Subject: Transmittal of P-5 and P-6  
Solid Waste Permit LF-0001-08  
West Hawaii Sanitary Landfill

Subject: Geosyntec Consultants Response to DOH Permit Renewal Application Comments  
Solid Waste Management Permit No. LF-0001-08  
West Hawaii Sanitary Landfill

**Subject: Response to Permit Renewal Application Comments  
Solid Waste Management Permit No. LF-0001-08  
West Hawaii Sanitary Landfill**

Subject: Response to Permit Renewal Application Comments  
Solid Waste Management Permit No. LF-0001-08  
West Hawaii Sanitary Landfill

Model: Bedrock (Impenetrable)

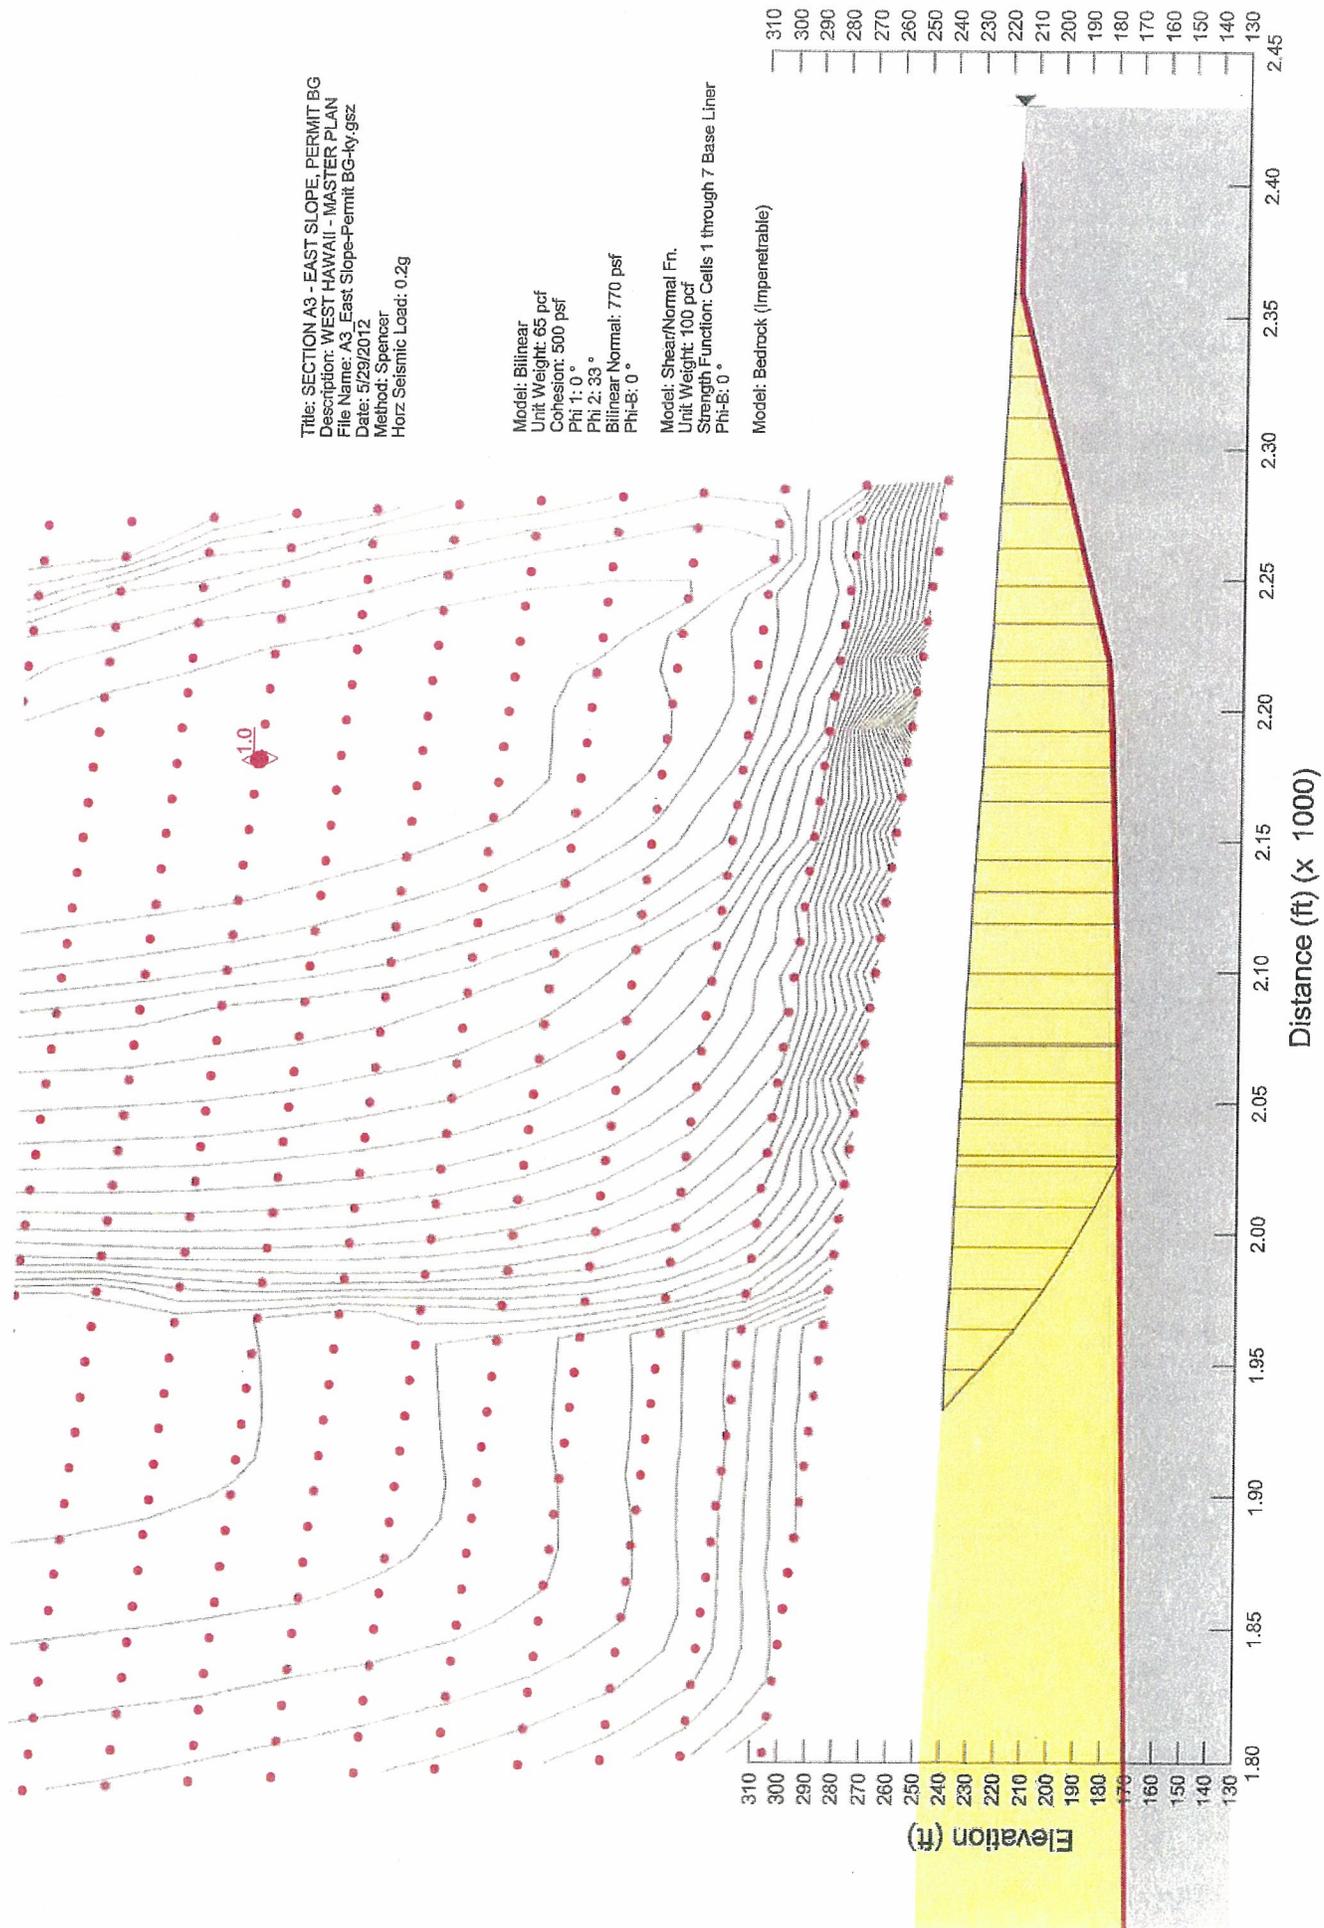
**Response to Item 5.a. Your Master Plan Report of March 2012 includes slope stability analyses for cross sections through Cells 8-15 and Cells 16-23. Please also evaluate and include a slope stability analysis for a cross section through Cells 1-7.**

Using the existing permitted base grades and the revised final grades as per the 12 March 2012 *Master Plan Report*, the landfill slopes are stable.
